Project: S-8
Docket: 70-36

UNITED NUCLEAR-WALLINGKRODT -- DOCKET 70-36

We have reviewed the United Nuclear applications dated December 28, 1961, and January 5, 1962, requesting approval of shipping procedures for UO_2 pellets with enrichments up to 5% U-235.

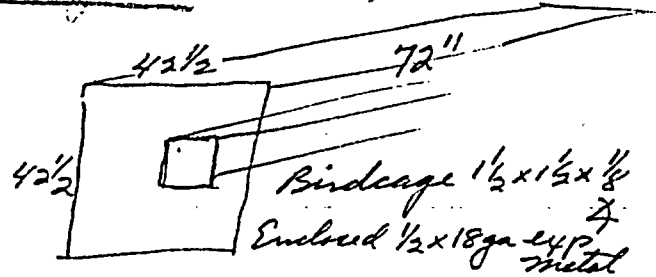
Wt. loads to 1.8 x M_0 per Fig 13 (for 1.8% enr)

Example: Enr. 2.4%

$$M_0 (\text{Fig. 13}) = 1.2 \text{ kg}$$

$$M = 1.2 \text{ kg} \times 2.16 \text{ kg} \times 2.16 \times \frac{1}{0.65} \times \frac{1}{0.82} = 102.5 \text{ kg}$$

However, only 134 sticks or 96 kg UO_2 can be placed

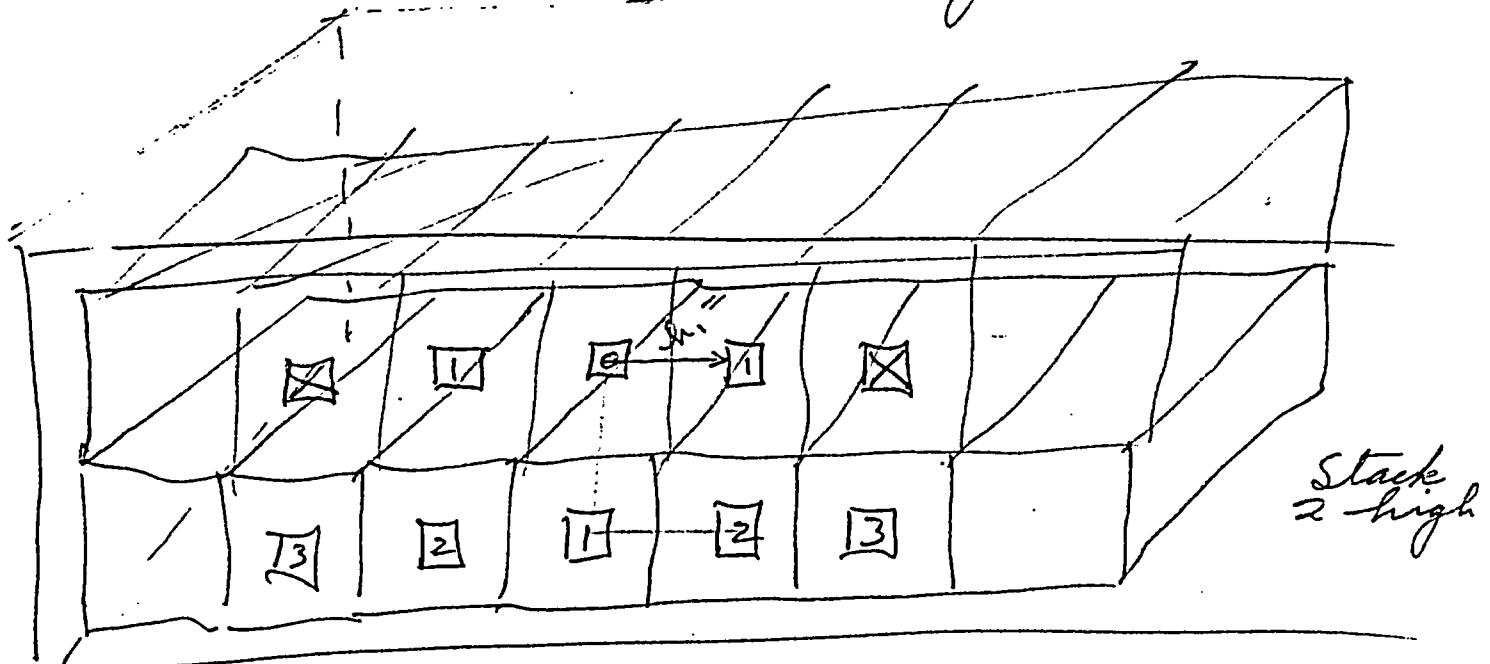
can truck will hold?

$\bar{r}_f = .093 (1.17 \text{ ster})$; With twin $r_f = 0.135 (1.7 \text{ ster})$

Since $k_{eff} = 0.65$, max $r_f = 0.20$, so spacing is OK.

Avoid commingling by instructions on B/L.
